Access Compliance Report

Public Rights-of-Way

(Curb Ramps)

Intersection ID: 42496	Main Street: ALMA_BLOUNT_BV	Cross Street: TOMLIN_GREEN_LN	Location: NE
ADA ID: B496CBF6D124	Ramp Type: PerpDiag	Initial Pass/Fail: Pass	Overall Compliance: No
Severity Score: 12.75			
Codes/Mitigation Info/Possible Solution		Field Measurements/Component Compliance

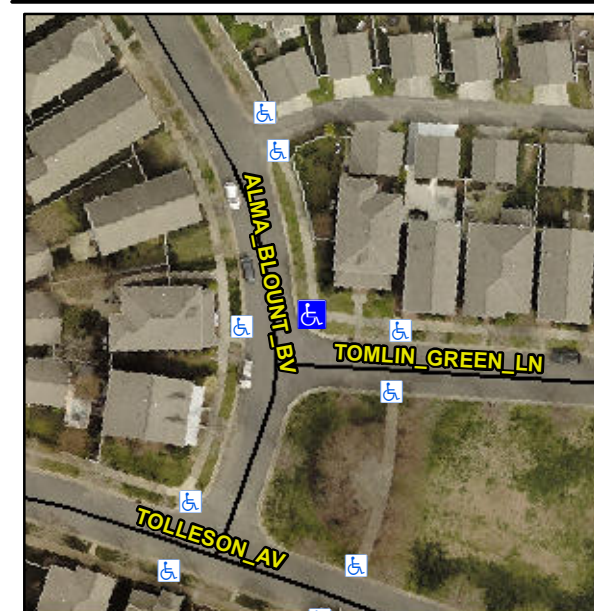
Not Found, R304.5.3, R304.2.3, R305

Compliance	Description	Data	Compliance	Description	Data
N/A	Ramp Length (in)	75.0	Yes	Ramp Slope (%)	7.0
Yes	Ramp Width (in)	50.0	No	Ramp XSlope (%)	3.4
N/A	Flare Type LT	Sloped	N/A	Flare Type RT	N/A
N/A	Flare Slope LT (%)	10.2	Yes	Flare Slope RT (%)	0.4
N/A	Flare Traversable LT?	Yes	N/A	Flare Traversable RT?	Yes
Yes	Landing Length (in)	60.0	No	DWS Provided?	No
Yes	Landing Width (in)	50.0	N/A	DWS Contrast?	No
Yes	Landing Slope (%)	1.5	N/A	DWS Length (in)	N/A
Yes	Landing X Slope (%)	0.4	N/A	DWS Full Width?	No
N/A	Landing Curb? (Y/N)	No	N/A	DWS Offset (in)	N/A
N/A	Shared Landing?	No			
Yes	Gutter Ponding?	No	Yes	Gutter Slope (%)	4.4
Yes	Gutter Lip Ht (in)	0.0	No	Gutter X Slope (%)	3.2
N/A	Painted X Walk1?	No	N/A	Painted X Walk2?	No
	X Walk 1 Direction	To W		X Walk 2 Direction	To S
N/A	X Walk 1 Width (in)	N/A	N/A	X Walk 2 Width (in)	N/A
	X Walk 1 Slope (%)	0.2		X Walk 2 Slope (%)	0.4
	X Walk 1 X Slope (%)	1.8		X Walk 2 X Slope (%)	5.2

N/A	Ramp inside XWalk1?	N/A	N/A	Ramp inside XWalk2?	N/A
	Road Slope (%)	2.2	N/A	Clear Space?	Yes
	Road X Slope (%)	0.8	N/A	Clear Space to XWalk (in)	N/A
Yes	Any Obstructions?	No	Yes	Storm Grate/Utility Hazard?	No
	Obstruction Type			Storm Grate/Utility Type	
		N/A			N/A
			Yes	Surface Condition? (G/P)	Good

Remove & Replace Curb Ramp With Two New Directional Ramps or Equivalent. Remove & Replace Gutter.
